RE: Drainage Report for SAD 227 (E-10, D-10) Dated June 12, 2003

SAD 227
Unser Boulevard Middle Section
Drainage Report

Re: Response to 30 May 2003 Letter
WCEA File: X1-218-025

Re: Response to 5 May 2003 Letter
WCEA File: X1-218-025

City Project No.	Zone Map No.	Sheet
707391	X-XX	PLATE 1

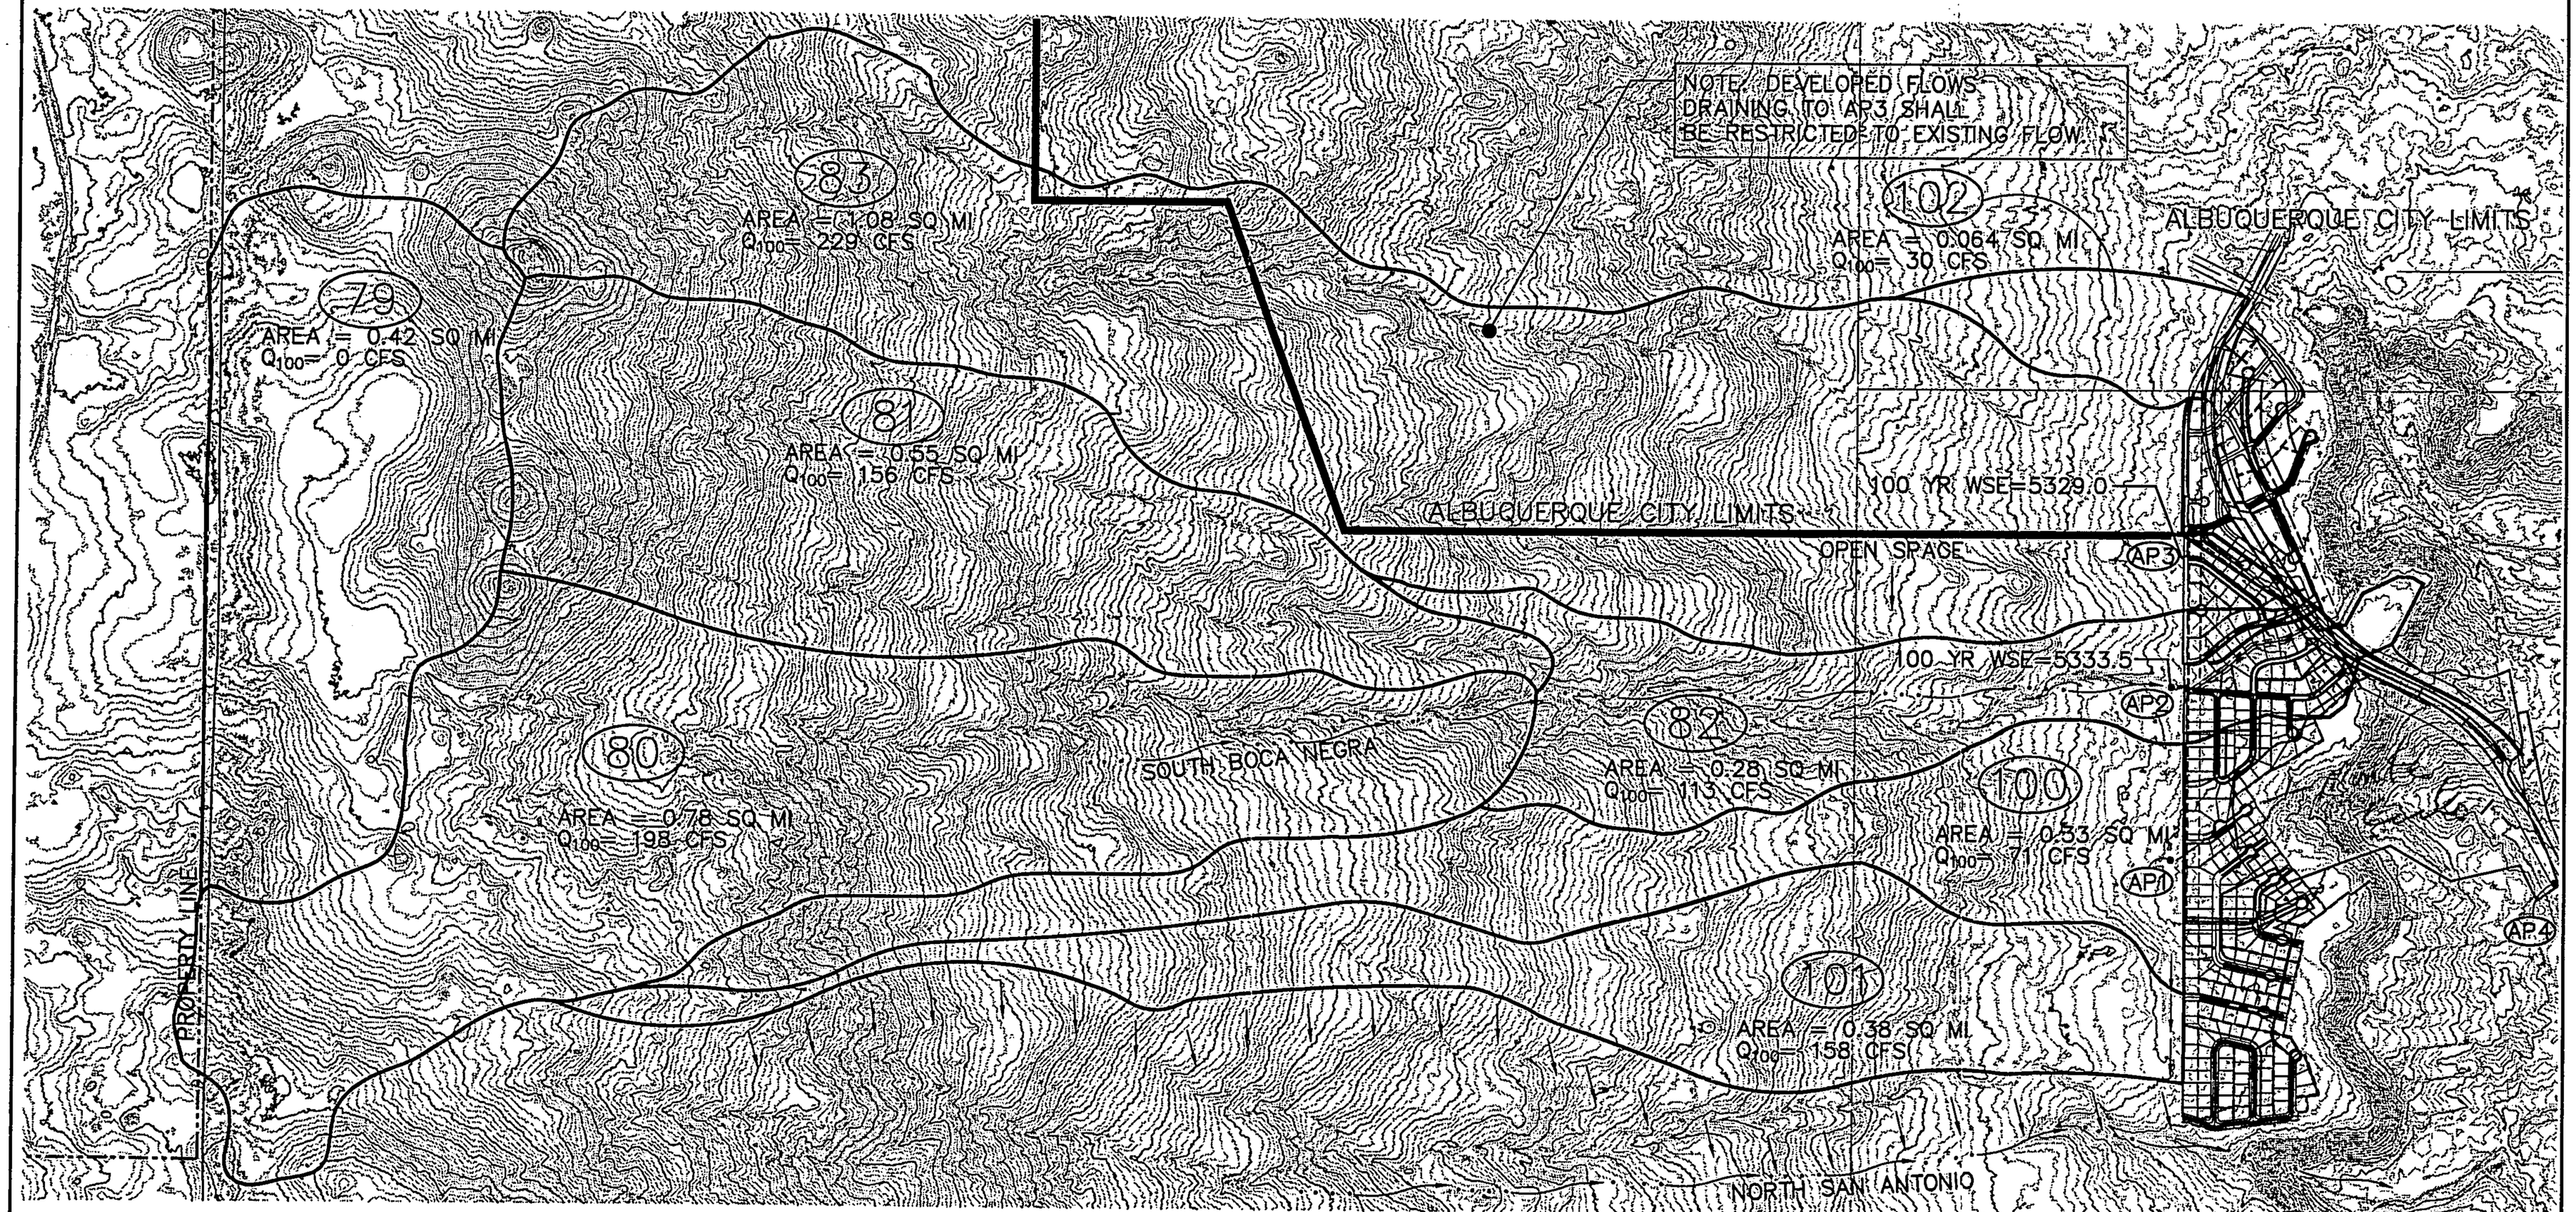
1. Please submit routing calculation to show how the runoff was routed through the storm drain. The runoff in the storm drain is lower than what is produced for the development and off site flows.
2. AP 1 is not at the low point. How will runoff enter the storm drain? If runoff is going to be backed up an AP 1 please show the 100-year water surface. Does Open Space agree with this ponding?

1. The basins have been revised to follow the existing contours, see Plate 1.
2. The basins have been revised and all flows have been updated, see Plate 1.
3. A meeting was held with the property owners and development was coordinated, all parties agreed with the plan included in this report

City Project No.	Zone Map No.	Sheet
707301		PLATE 1

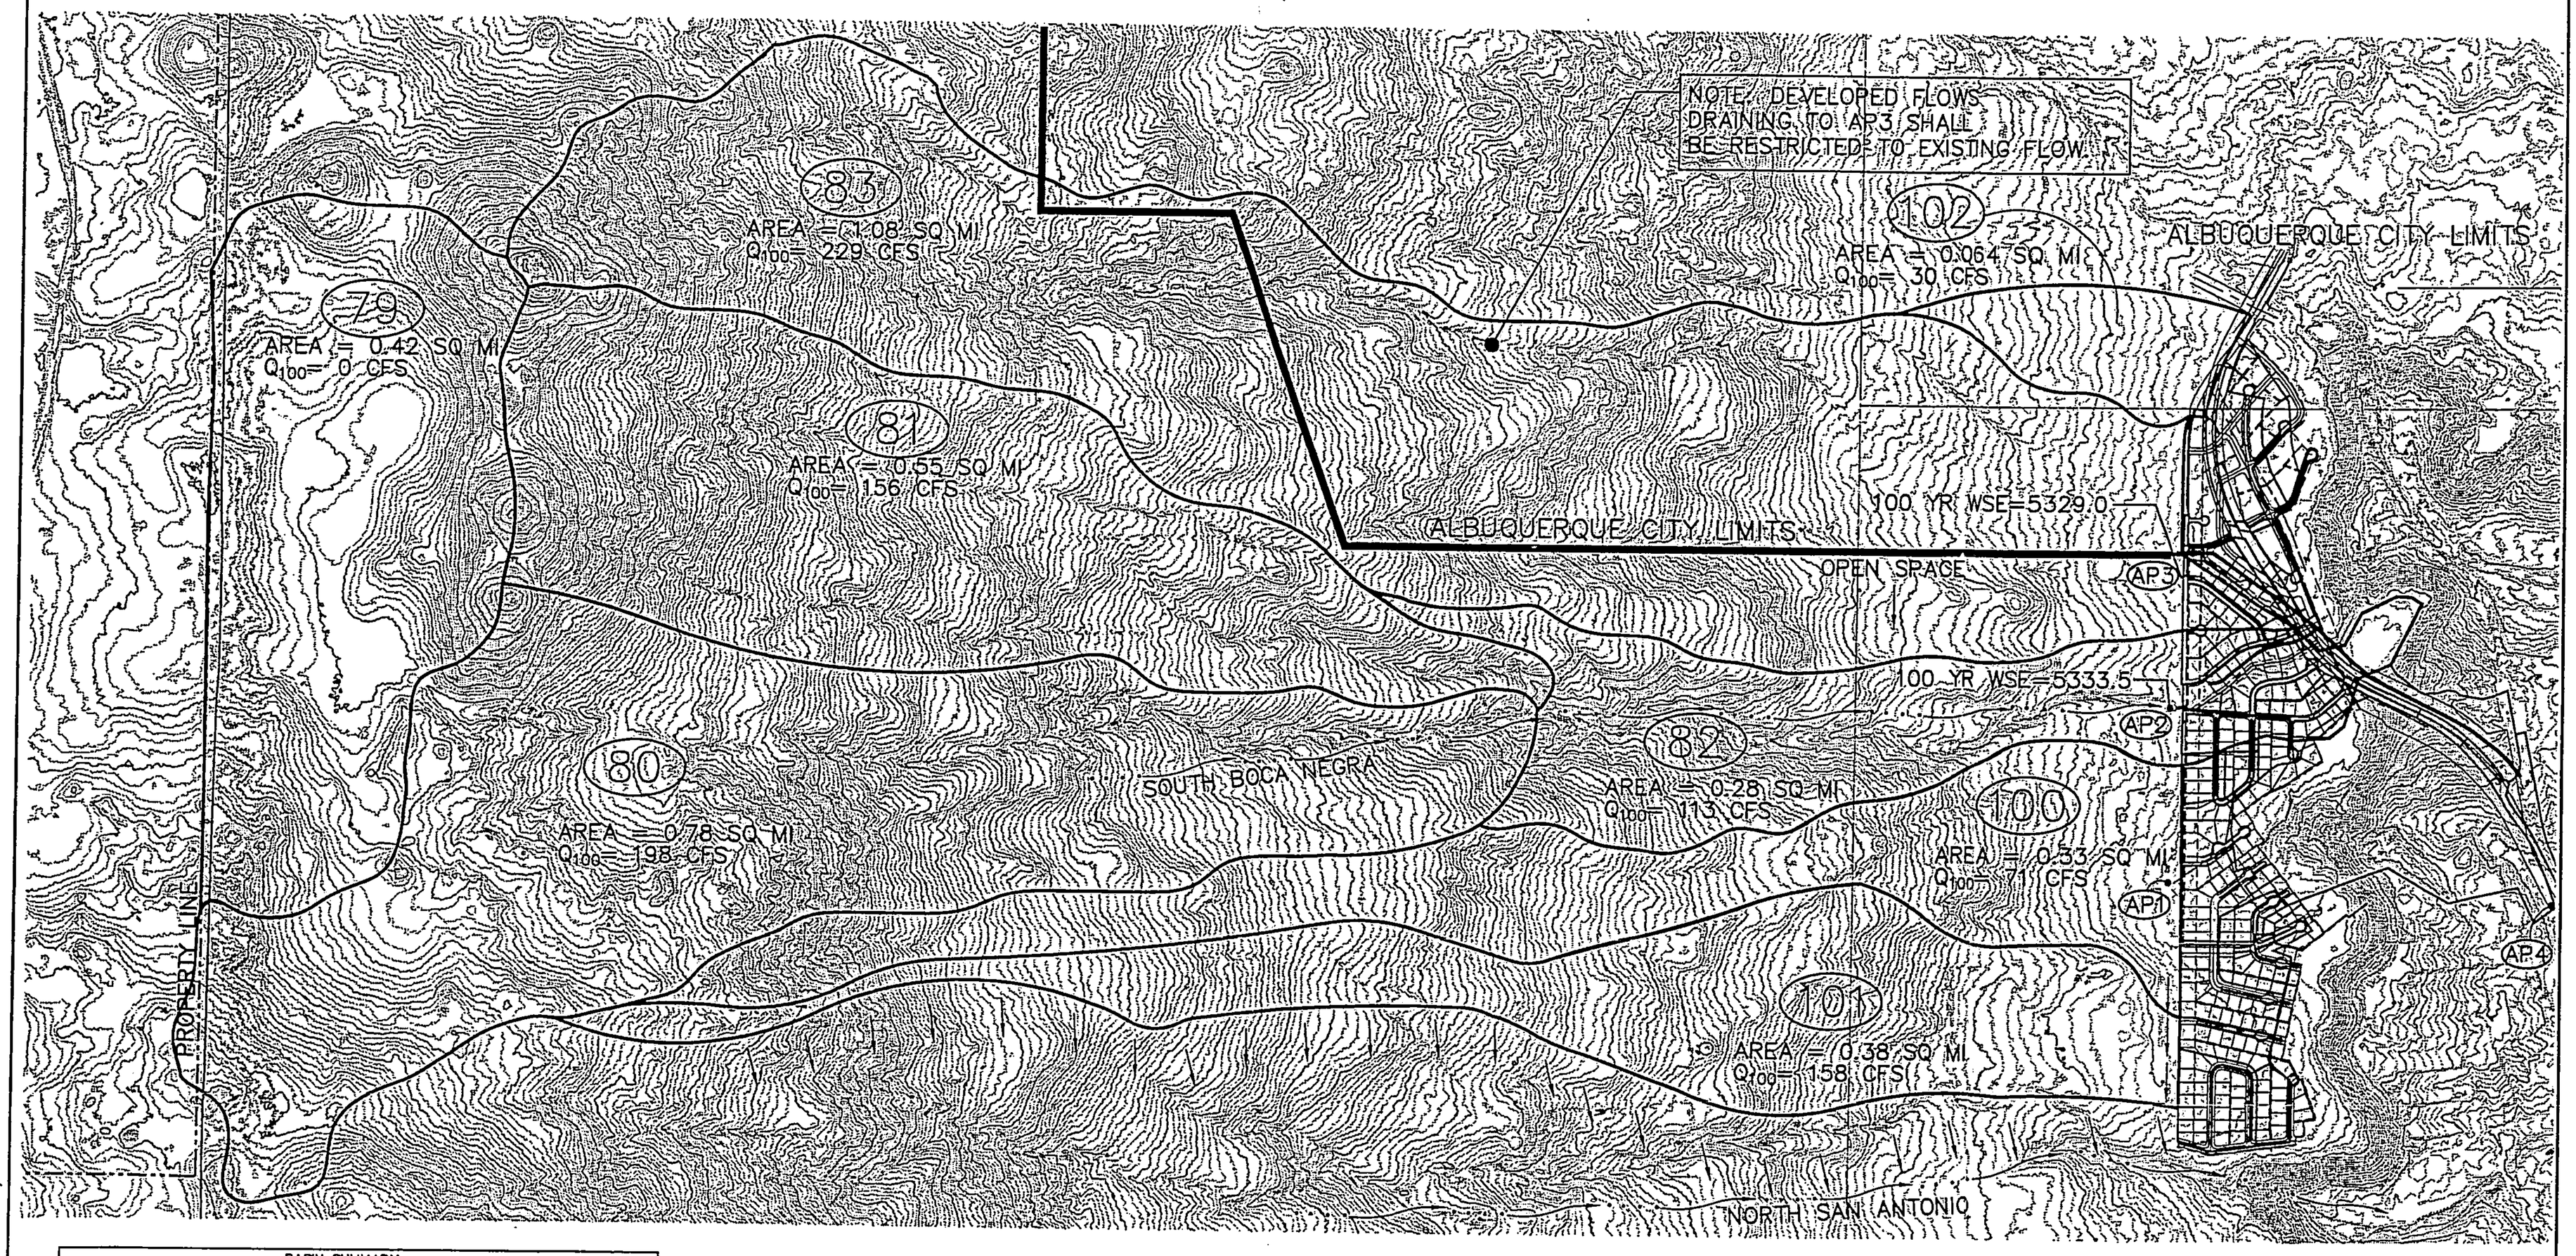
1. Please submit a map showing the ownership of the upstream basins above the SAD area. Please show roads and the future drainage basins. The upstream runoff basins should follow the developed property lines and not existing drainage basins. The runoff should be calculated for developed flows and the hydraulic structures through the SAD should be designed for onsite and offsite developed flows.
